Interactive comment on “A framework for assessing flood frequency based on climate projection information” by D. A. Raff et al.

Response to Individual Comments: Original Reviewer comments indicated by number. Responses to comments immediately follow.

Fig. 1. Supplemental Figure 1: Full Caption in Text

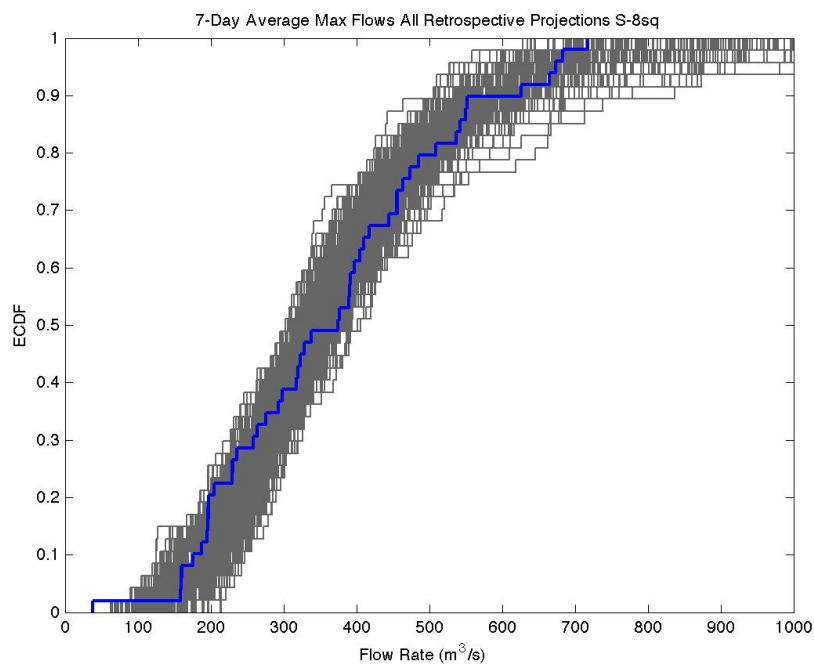
model. I see here the possibility that potentially important and presently unaccounted for model errors are being introduced in the authors analysis. This is because the precipitation and temperature data from which the forcings for the hydrology model are derived are themselves outputs from any one of several climate models. These climate models explicitly model physics at the land surface and are therefore associated with particular rainfall-runoff sequences. Moreover, the land surface parameterizations in these climate models are explicitly coupled to the atmosphere through latent heat flux that is soil moisture dependent. Correspondingly, the temperature and precipitation regimes that emerge from these climate models are associated with particular rainfall-runoff regimes that are a result of the particular representation of the physics in each climate model. The authors have treated the hydrological model used in this study as being independent of the parameterization schemes embedded within the climate models from which the hydrologic model forcings are derived and have not reported on any efforts to verify that the hydrologic model used for the flood frequency analysis yields runoff volumes that are consistent with the runoff volumes produced by the climate models.

(2) Moreover, because the temperature and precipitation outputs used to derive the forcings for the hydrological model are obtained from a range of climate models that together span a broad range of parameterization schemes, it is likely that there is a correspondingly broad range of rainfall-runoff regimes that emerges from these climate models. The authors have used calibrated parameters for the hydrologic model, which remain fixed throughout the analysis. Setting aside for a moment the debate as to whether the changes in terrestrial vegetation associate with climate change would alter the rainfall-runoff characteristics in a way that would require adjustment of the model parameters, it seems that the variation between the physics of the climate models alone, and the corresponding variation in rainfall-runoff regimes these physics impart would necessitate the explicit treatment of uncertainty in the parameters and/or structure of the hydrological model. An explicit treatment of the uncertainty in the hydrologic model would, in principle, ensure that the rainfall-runoff regimes simulated by the hydrological model in response to forcings derived from a suite of climate models spans the range in rainfall-runoff regimes associated with those climate models. I see this as being a potentially important inconsistency in the authors' framework that would be particularly important in areas where the coupling between precipitation and soil moisture are thought to be strong. I suggest that the authors include a little more justification for their choice to neglect potential disparities in physics between the climate and hydrological models throughout the flood frequency analysis, and a discussion of the potential magnitude (if known) of discrepancies between the rainfall-runoff partitioning of the climate versus hydrological models.

If it is a question about whether the algorithm presented in the manuscript is able to reproduce the antecedent period and calibration period of the Sacramento model it is shown (Figure 4) that peak values are well reproduced. Reviewer Flores identifies that

volumes may be an issue as well. Here please see Supplemental Figure 1 that show that, like the peaks, volumes are also well reproduced. This figure was not included in the initial manuscript over the concern with density of information and length of the document.

Supplemental Figure 1: Performance of methodology to reproduce antecedent runoff performance. Boise River basin above Lucky Peak Dam 7-day annual maximum average flows (7-day volume is 7 x Flow Rate). Blue line represents empirical distribution function (ECDF) for the calibration set 1967 – 1997 for the SAC-SMA model. Grey lines represent ensemble of projections for the same 1967 – 1997 period.
